Response to SC&A Comments on ORAUT-RPRT-0092

Event Title: Savannah River Site Working Group

Date: November 17, 2020

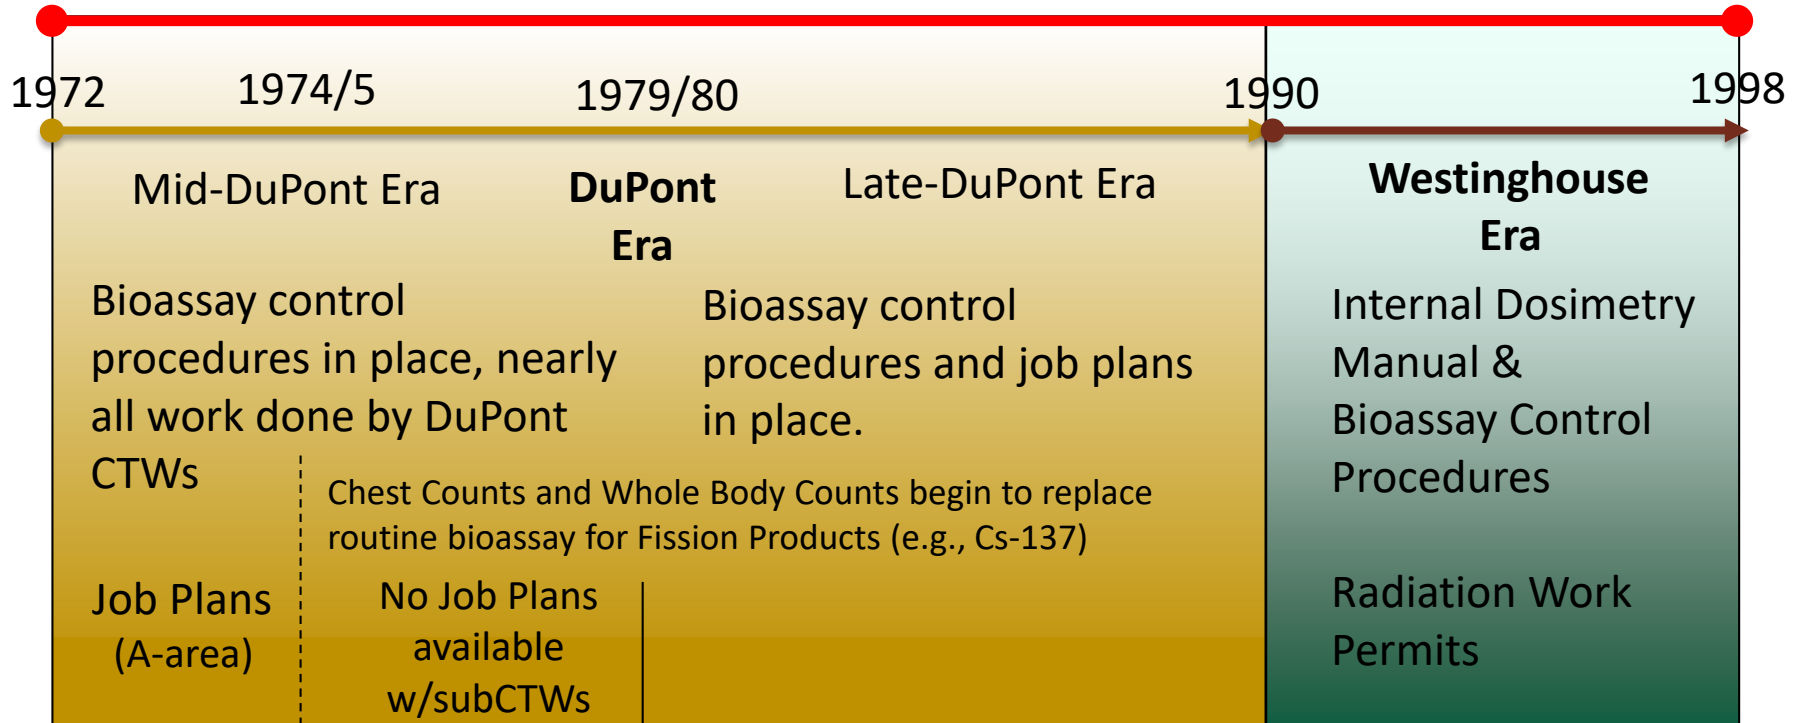
No SWPs or job plans sampled by NIOSH for 1972 – 1990 contain any requirements or indications for job-specific bioassays, despite respiratory protection being required, bringing into question the approach taken to satisfy RPRT-0092's first evaluation objective which was to determine the fraction of subCTWs identified on RWPs of interest who were monitored for internal intakes.

This finding questioned the completeness of the dataset for subCTWs during the DuPont era (1972-1990).

- NIOSH contends that even though the bioassay choice may neither have been checked nor entered on the standard work permits and job plans between 1972 and 1989, there was an ample number of bioassays taken after respirator work was conducted to verify workplace controls.
- RPRT-0092 used the era-specific criteria to determine if bioassays should have been taken for the 1972–1989 time period.
- Bioassays were obtained based on the operational philosophy, management approach and procedures at the time.

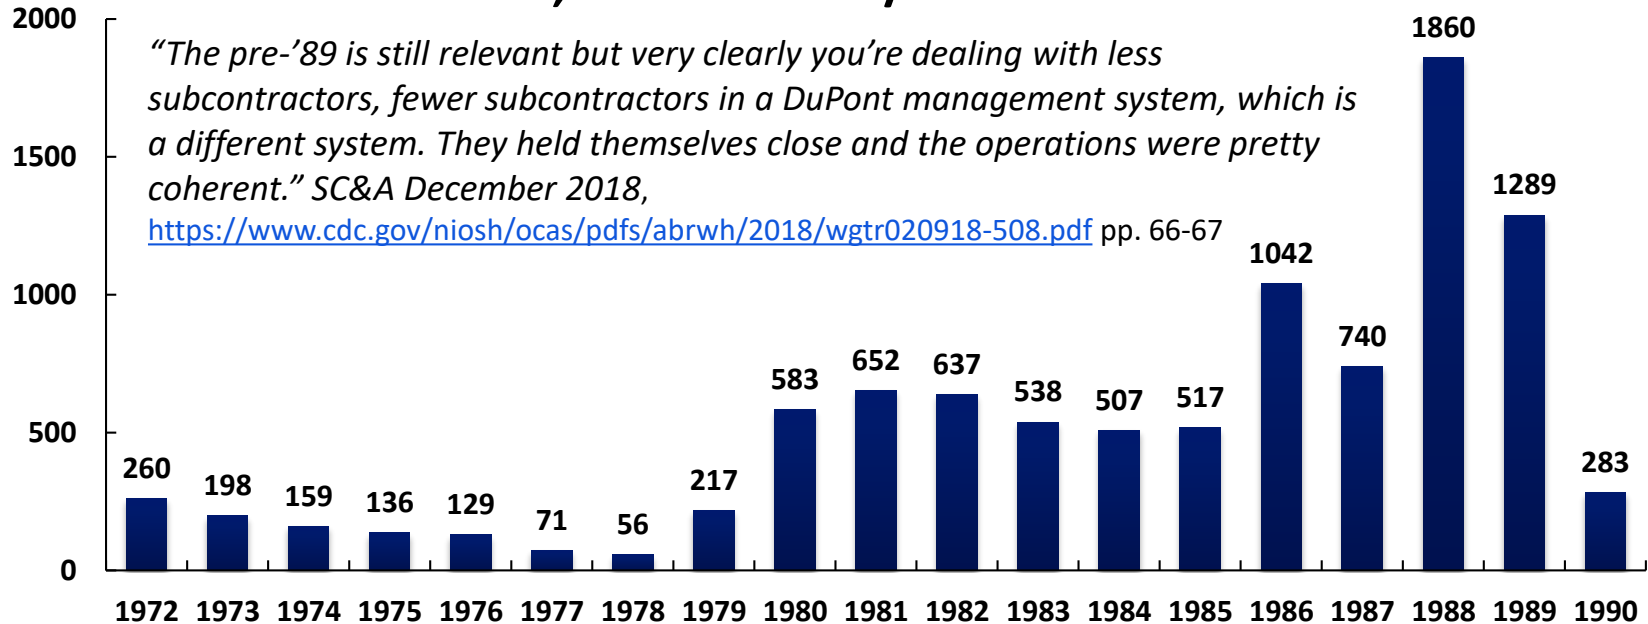
The scope of permit sampling for 1972 – 1990 at SRS is essentially limited to one facility, 773-A, falling short of achieving NIOSH's sampling objective and the representativeness called for in NIOSH's coworker [co-exposure] guidelines.

This finding challenges the completeness of the data for subCTWs, primarily between 1972-1979, since only SWPs or Job Plans were only found for 773-A.

- NIOSH believes that subCTWs were adequately monitored in areas outside 773-A between 1972 and 1990. Additional reviews of the plutonium logbooks support the representativeness called for in the co-exposure implementation guide.
- NIOSH reviewed available plutonium logbooks (1972-1990) in order to determine a more complete picture of bioassay monitoring practices for subCTWs. At least 11,316 bioassay samples from at least 7,028 subCTWs were identified from 1972 through 1990 in at least 23 areas at the site.

Dose Reconstruction for fission products

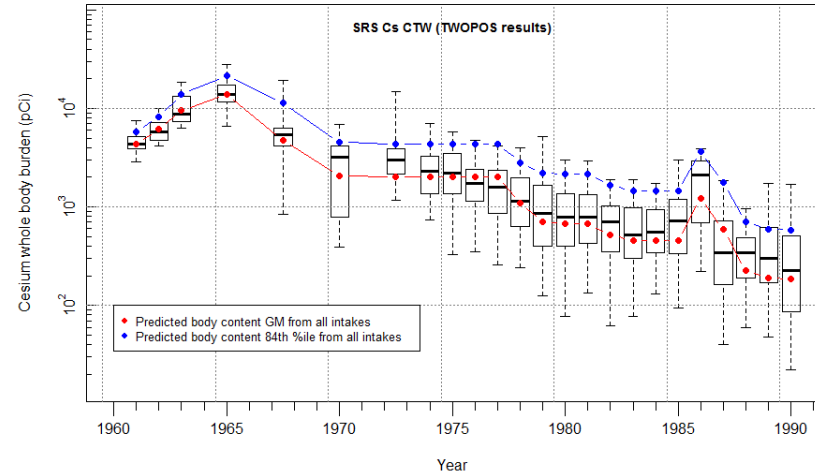
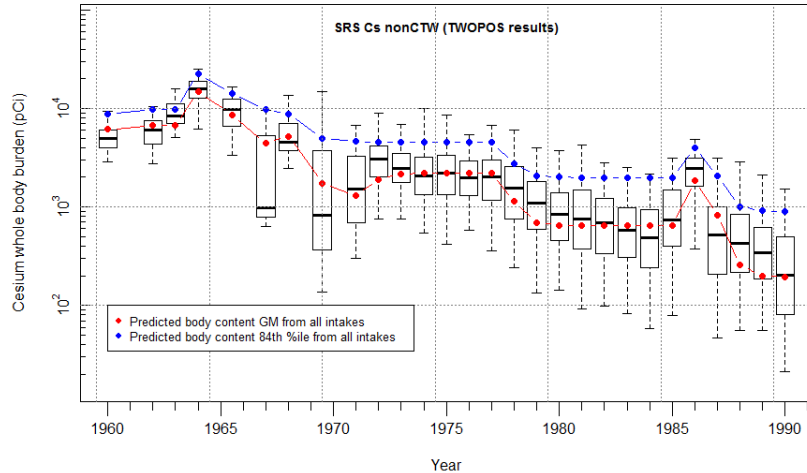
Many of the workers (around 70–73 percent) who should have been monitored for fission products underwent appropriate internal sampling during the two periods evaluated prior to 1990 (1972–1974 and 1980–1989). However, very few of these monitored workers underwent in vivo counting for fission products. Thus, they are not included in the coworker model developed for SRS and are not considered representative of the unmonitored worker.

NIOSH believes there are sufficient data to reconstruct FP doses for unmonitored subCTWs.

- Actual fission product urinalysis results reported for individual subCTWs will be used to reconstruct fission product doses.
- Co-exposure models are stratified to CTW (prime plus subcontractor).
 - Prime CTWs were routinely monitored during the entire period while subCTWs were monitored by special urinalysis up to 1982.
 - **By 1976**, WBCs replaced FP urinalysis to detect FP intakes.
 - The co-exposure model may use all applicable bioassay data, including results from special and routine bioassay samples, if needed.
 - The model is valid for subCTWs as the data for all CTWs are sufficient for dose reconstruction purposes.

- Although subCTWs are underrepresented in the fission product co-exposure model until 1983, the model is still valid for subCTWs because the data included for prime CTWs are sufficient to reconstruct doses.

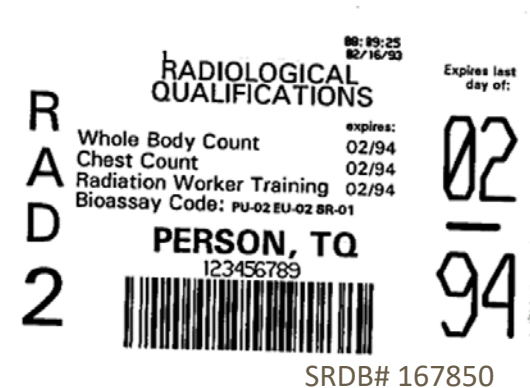
For both the 1972–1989 and the 1990–1998 periods, when considering all radionuclides requiring internal monitoring per work permit, as opposed to “at least one radionuclide” requiring monitoring, the percentage of monitored workers drops significantly (particularly in the earlier periods). Directly monitored workers ranged from 47 percent to 77 percent (in comparison to 76–96 percent in RPRT-0092), and effectively monitored workers ranged from 55 percent to 89 percent (in comparison to 85–99 percent in RPRT-0092).

- The original intent of this work was to determine if subCTWs were monitored working in the same environments as other workers.
- The sampling plan for the Westinghouse era (1990-1998) considered a worker as monitored if they had **at least** one bioassay results.
 - Worker leaves bioassay based on either their routine schedule or job-specific requirement
- NIOSH stands by the results given for effectively monitored workers. There is sufficient data to reconstruct doses using a coexposure model.
